Re : West Dollarhide Queen Sand Unit No. 135
Amendment to C-108 to increase injection pressure

SIRGO OPERATING INC.
WDOJU #135
STEP-RATE INJECTION TEST

Re : West Dollarhide Queen Sand Unit No. 135
Amendment to C-108 to increase injection pressure

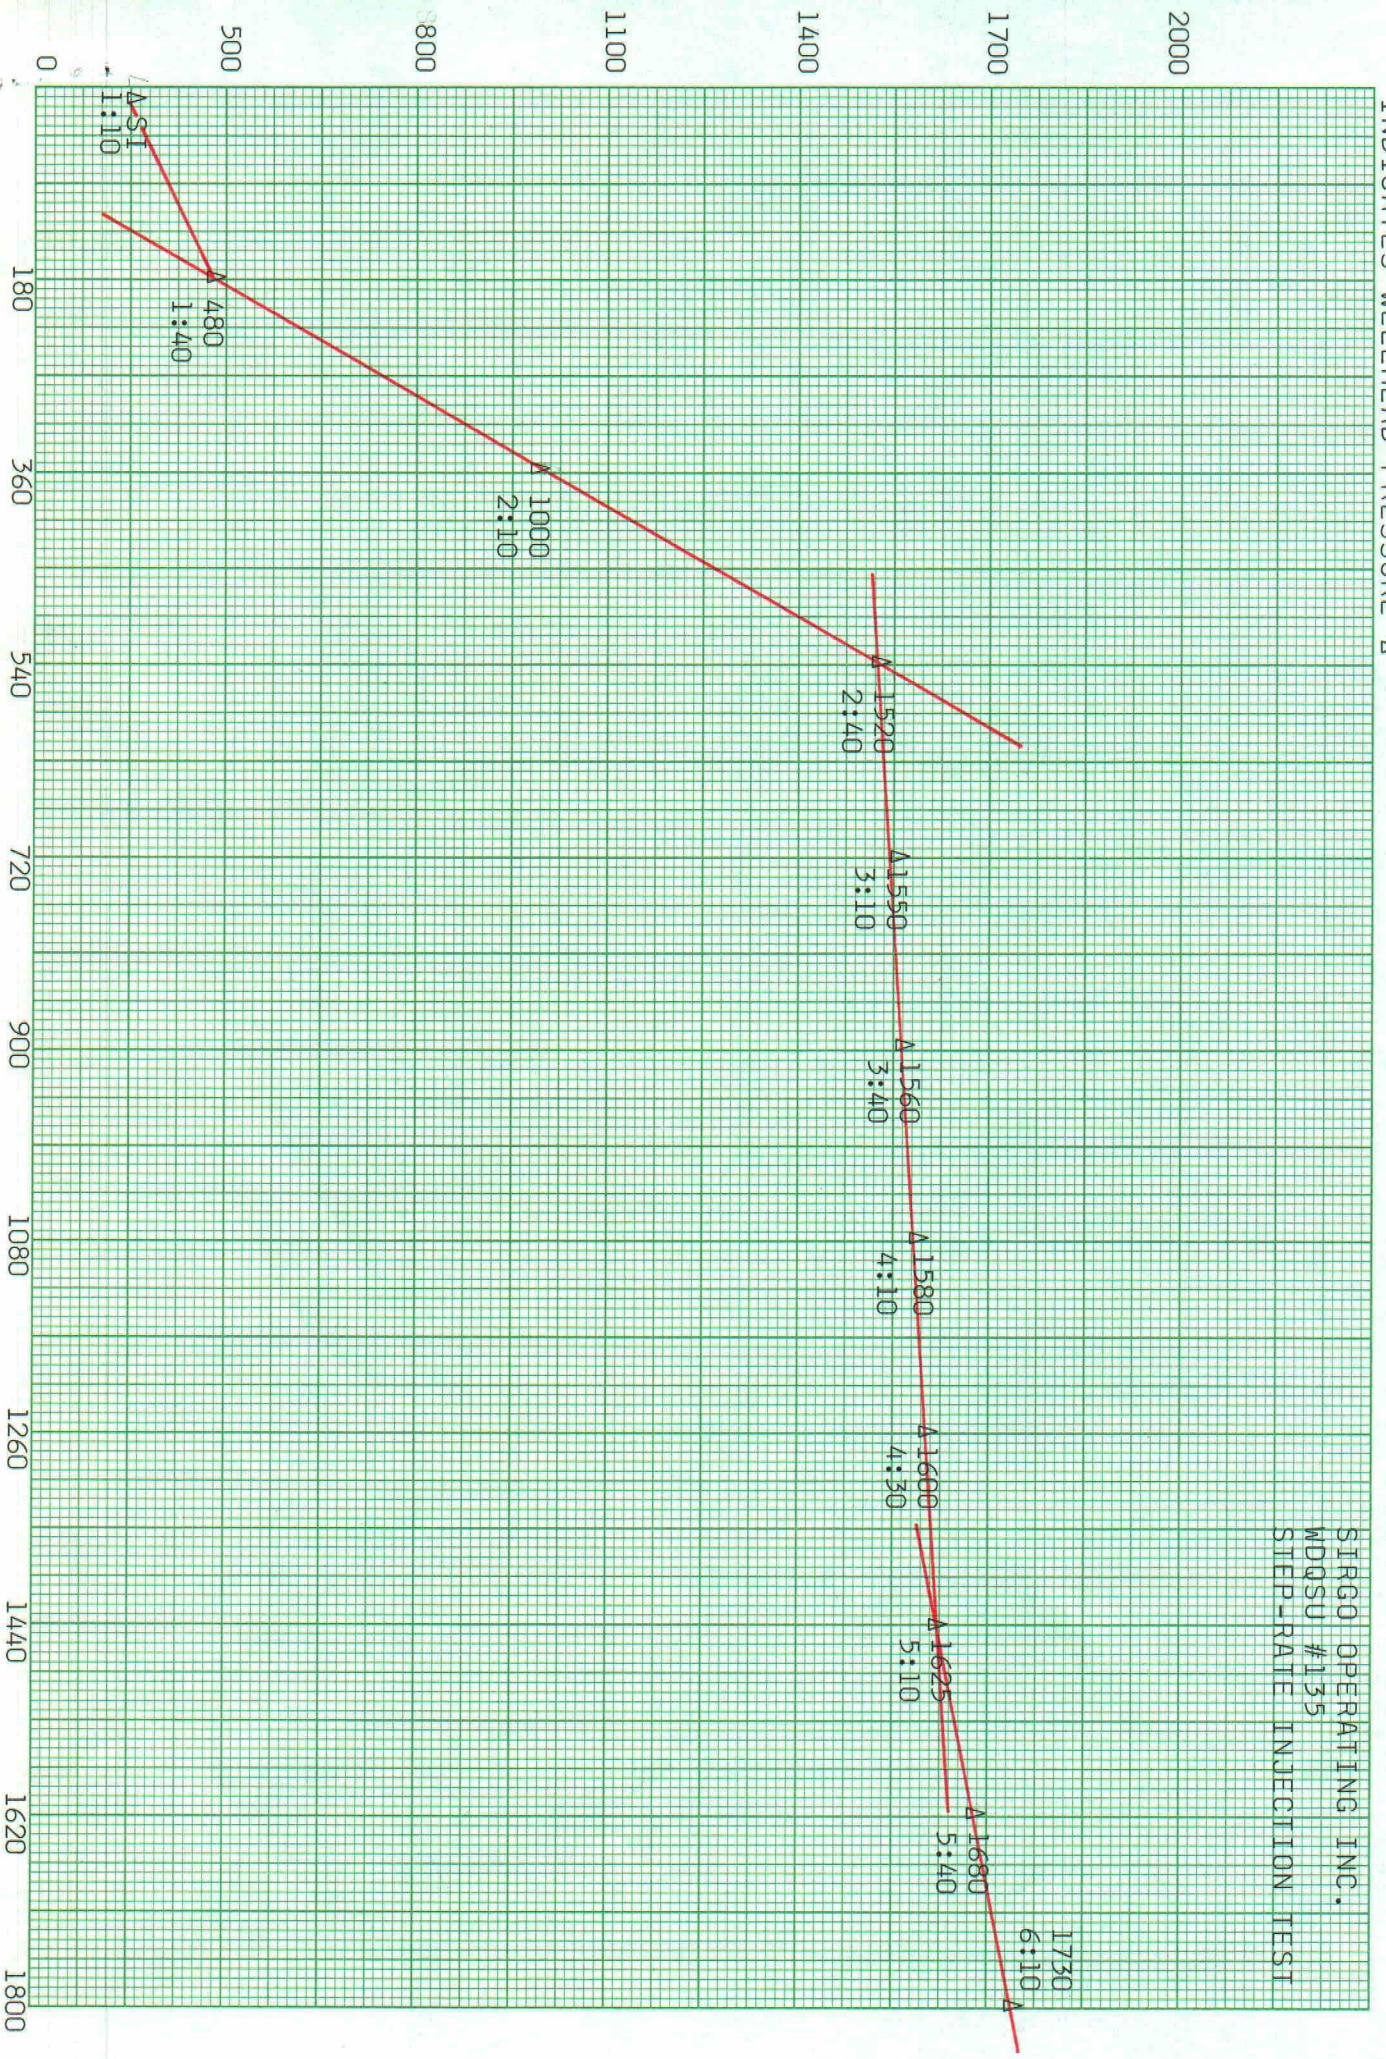
In response to your request of June 10, 1991 to repeat the step rate test that was run on the subject well on 4-24-91. Please find attached a step rate test run on the subject well on 6-25-91. The step rate test was re-run starting at a shut in pressure of 250 psi and up to and past the fracture pressure of 1520 psi.

Sirgo Operating Inc. respectfully request that the existing C-108 be amended to reflect an allowable wellhead injection pressure of 1520 psi for the subject well.

DATE 4/24/91

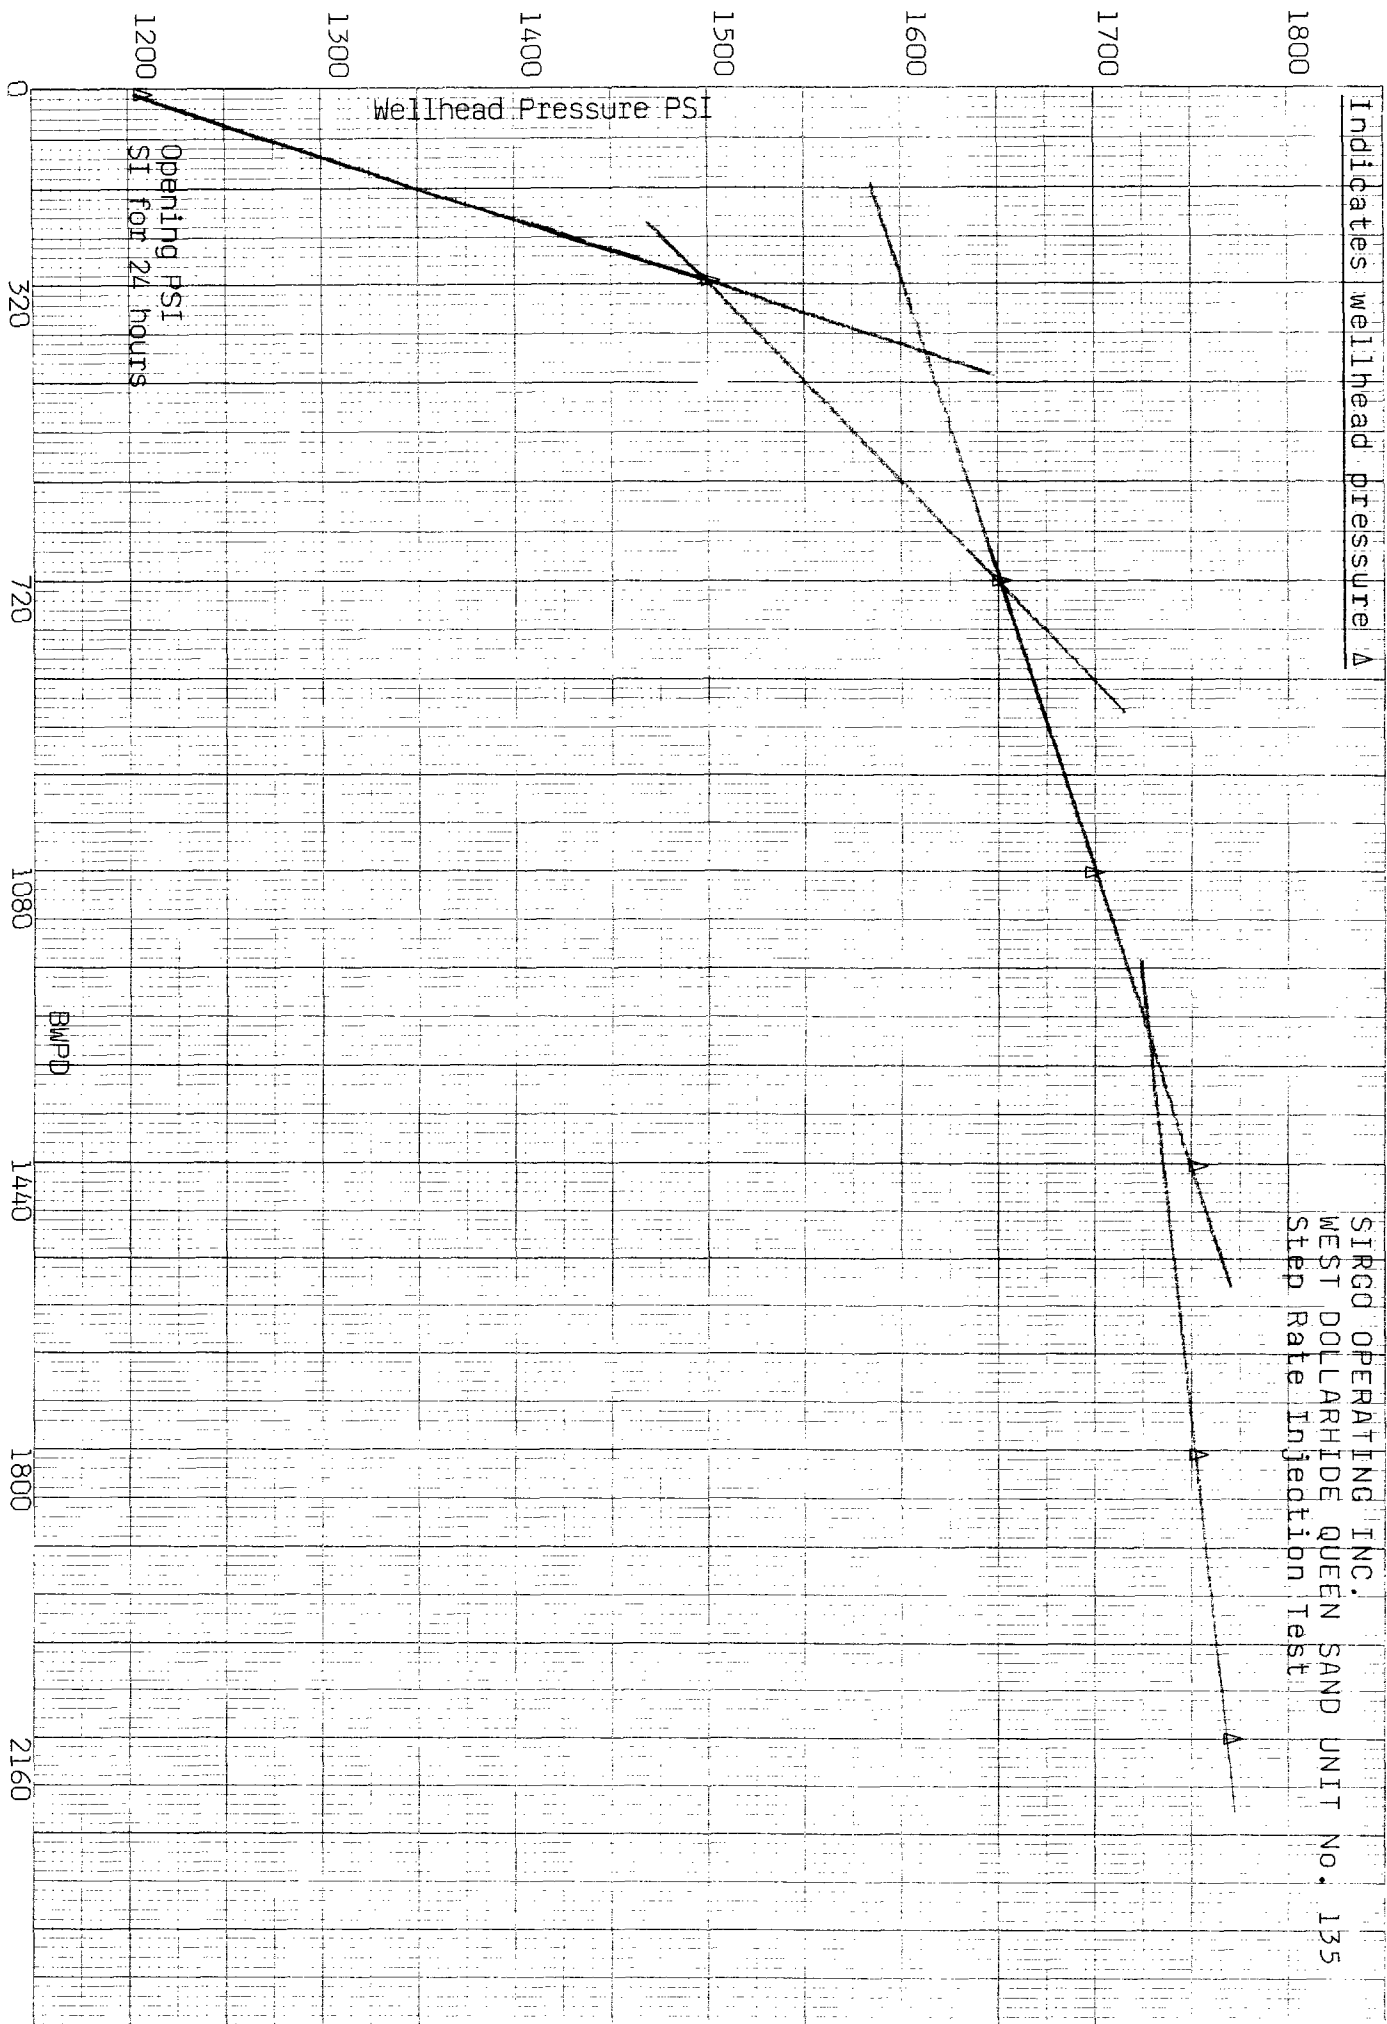
I have received and reviewed the step rate injection test conducted on the West Dollarhide Queen Sand Unit Well No. 135 on April 24, 1991, and have found that the test is unacceptable. According to Division records, the current surface injection pressure limitation on the well is 716 psi, and, the test was commenced at a wellhead pressure of 1200 psi. The Division normally requires that the wellhead pressure at the commencement of the test be below the current authorized wellhead pressure.

We request that you re-conduct the test on the well in accordance with acceptable test procedures.
